CURRENT DESIGN:

RESPONSE TO BOARD:

EARLY DESIGN GUIDANCE June 8, 2015 - DESIGN REVIEW BOARD GUIDANCE

NORTH
GROUND FLOOR PLAN

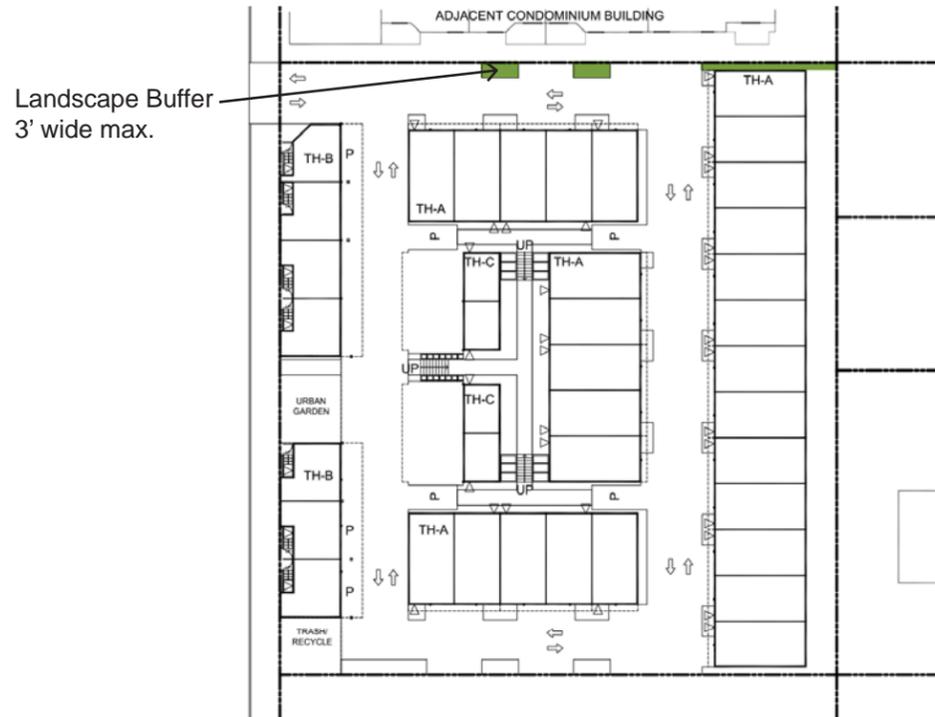
- (1c) Board appreciated variance in height that located lower heights near site boundaries.
- (2a) Board preferred schemes with one curb cut
- (2b) Board supported the pedestrian corridor and the location of the urban garden as a way for users to activate it more regularly and connect it to the rest of the development. There was concern with the width in relation to the height was not adequate to create a welcoming space.

- (2c) Encouraged applicant to design drives a “woonerven” or shared streets to accommodate pedestrians and vehicles... The design should integrate landscaping and green features into the design of the space.

- (2d) Board indicated preliminary support for a decreased drive width in order to maximize usable open spaces and reduce impervious surfaces.
- (3a) Board had concern that the number of units constrained the size and function of open spaces.

- (3b) Design and locate Urban Garden to be the focal point of the overall open space and to make a gesture to the public realm.
- (3c) The Board encouraged activating the urban garden through design and integration with surrounding uses.

- (3d) The Board supports the idea of multi-use spaces
- (4a) The Board supported consolidating the live-works
- (4b) Locate the live-works to the south end of the site

- (1c) Reduced buildings 7 & 8 from 4 to 3-stories
- (2a) Created a single access point towards the north of the site to allow for a better pedestrian experience on 15th Ave.

- (2b) Used the drive width departure requested (2d) to widen the pedestrian corridor. The raised corridor will also minimize the height of the adjacent buildings.

- (2c) Drives are designed as woonerven with patterned paving, landscaping and height variation to designate pedestrian and vehicle spaces. The dead ends allow for protected areas for shared uses with minimal traffic.

- (2d) The reduced drive area was used to increase the open space landscaping buffers on the north and south side and to increase the width of the pedestrian corridor.

- (3a) One unit was removed to provide a larger and more functional Urban Garden. 39 units are the minimum for a successful development and this scheme provides the most open and space and landscape area.

- (3b) Maintaining a centralized location for the Urban Garden and placing it adjacent to the main pedestrian and vehicular access makes it the focal point of the project. It also connects to the raised pedestrian corridor to further emphasize the connection between public and private.

- (3c) A strong pedestrian connection ties the urban garden to the elevated courtyard between the paving and planting areas. It will be a community meeting point with mail delivery boxes and seating areas included in the design.

- (3d) The raised pedestrian corridors and drives with dead ends allow for protected areas for shared uses.
- (4a, 4b) Units were combined on the south end to create a better pedestrian experience closer to the main intersection and bus stop.

(1a,1b,2d) WIDENED TO 9' PRIVATE BACKYARDS
 (1c) BLDGS 7 & 8 REDUCED TO 3 STORIES

(2d) REDUCED DRIVE-AISLE WIDTH

(2b,2d) WIDENED PEDESTRIAN AREA TO 17' WIDENED GROUND FLOOR TO 19'

NORTH LANDSCAPE BUFFER	
HYBRID OPTION	CURRENT SCHEME
AREA:	233 SF
LENGTH:	64 LF

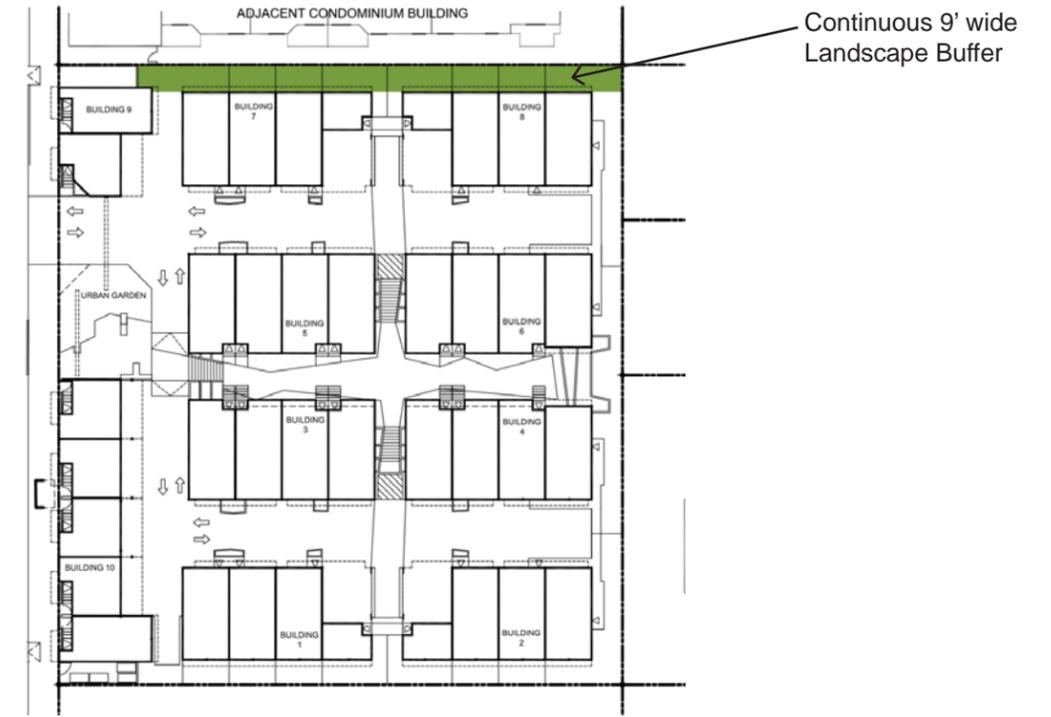
- Lush landscape buffers to all adjacent properties, especially north.
- Appreciated shorter units towards the edges of the site.
- Limit access to one curb cut to minimize impacts on the pedestrian environment and streetscape.
- Did not want bus stop moved further north.
- Preferred consolidation of structures on 15th .

Comparison Conclusion:
 The Current Scheme has more than six times the area of landscaping against the north property line. The wider and contiguous nature of the Current Scheme's Landscape Buffer will allow for more dense plantings and more privacy.
